Enclosure 4 to E-55865

SAR Changed Pages

Figure 1-7
Cask Handling Building Plan

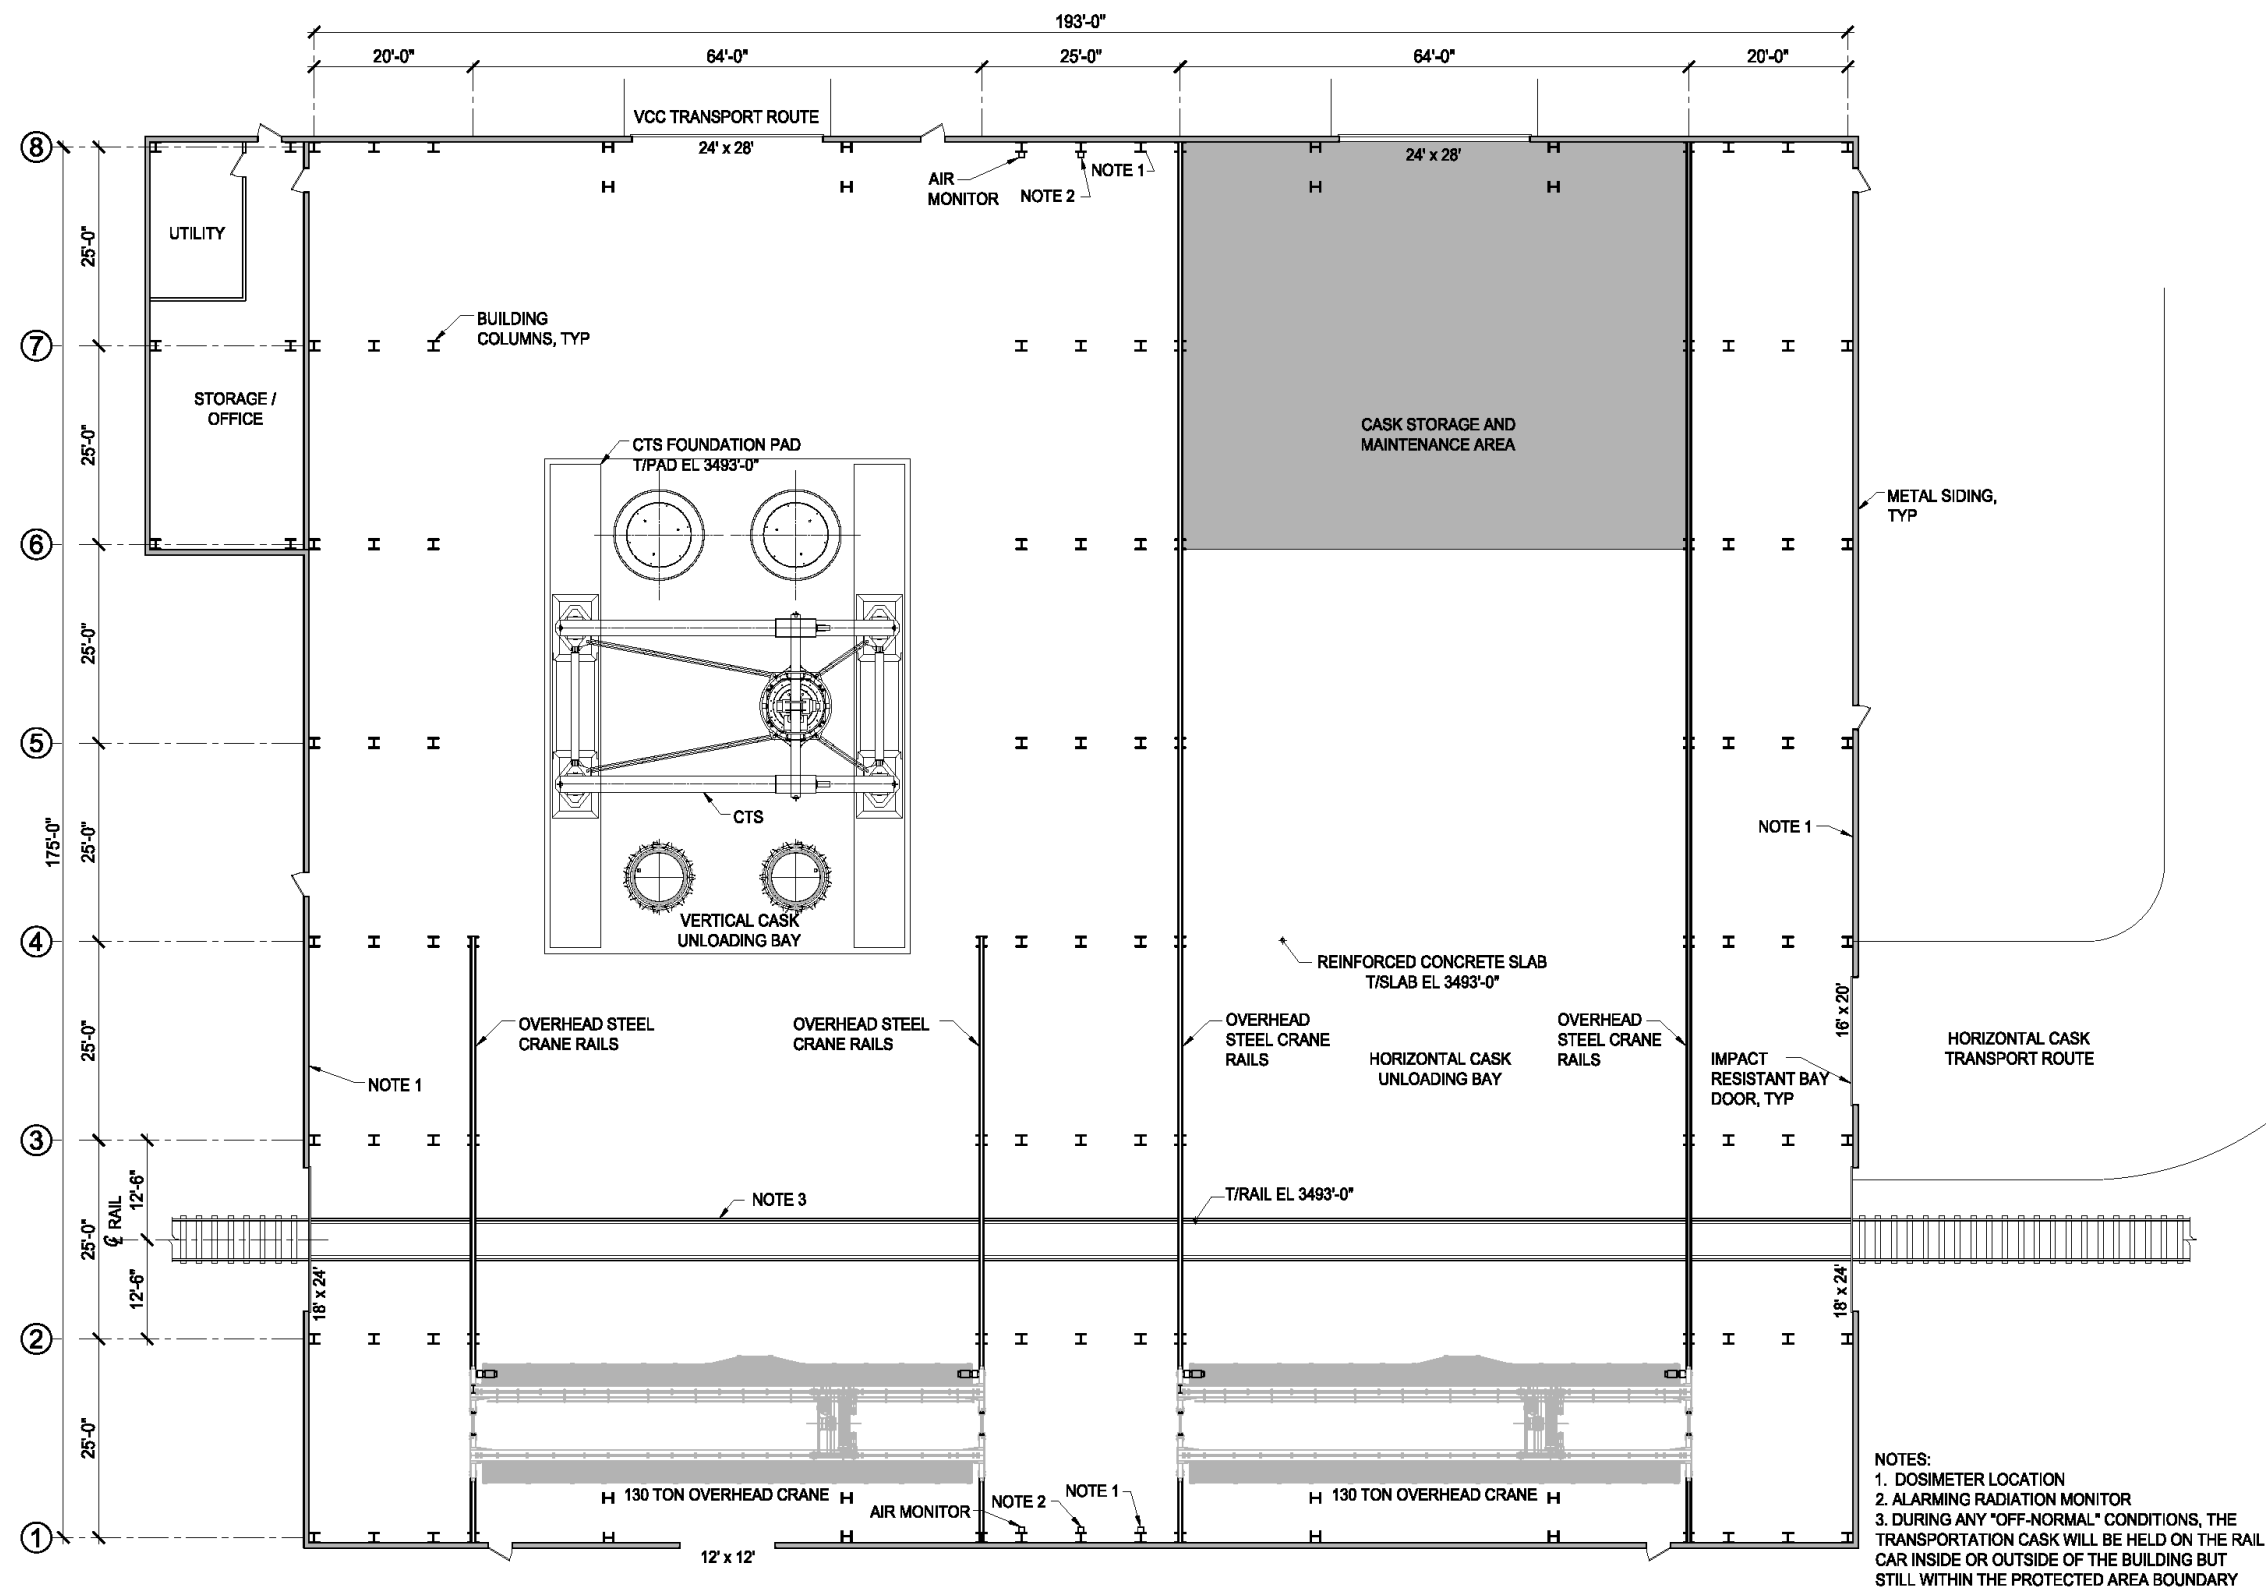
The bridge crane support system consists of simply-supported runway girders spanning 25 feet between the aforementioned independent crane support columns. As illustrated in Figure 1-7, the crane runways provide crane access to the complete length of the building in the east crane bay, while in the west crane bay the runways span only the four southernmost east-west column lines (from Line 1 to Line 4). Similar to the main building column lines, vertical bracing is provided in two bays of each crane column line (Lines D, E, I, and J); see the typical section shown in Figure 7-59. The runway girders are built-up steel sections with overall depth of 5'-6". At the top girder flange and at Elevation 136'-2", crane runway tie-back elements are provided to transfer lateral loads from the runway girders to the supporting vertically braced frames. The tie-back elements and their connections are detailed to accommodate flexural displacements of the runway without experiencing fatigue. The crane rail supported by the runway girders is 175 lb-per yard, ASTM A759 crane rail with rail clips sized and spaced to ensure both the rails and rail clips can withstand lateral crane operating loads as well as seismic loads.

The working floor of the CHB is provided by a reinforced concrete slab on grade that is structurally isolated from the CHB foundations and the CTS foundation. The slab is founded on compacted structural fill placed to a sufficient depth to remove loose in-situ materials, in accordance with the project geotechnical report. Thickened reinforced concrete sections are provided for support of the rails and railcars at the south end of the building (see Figure 1-7).
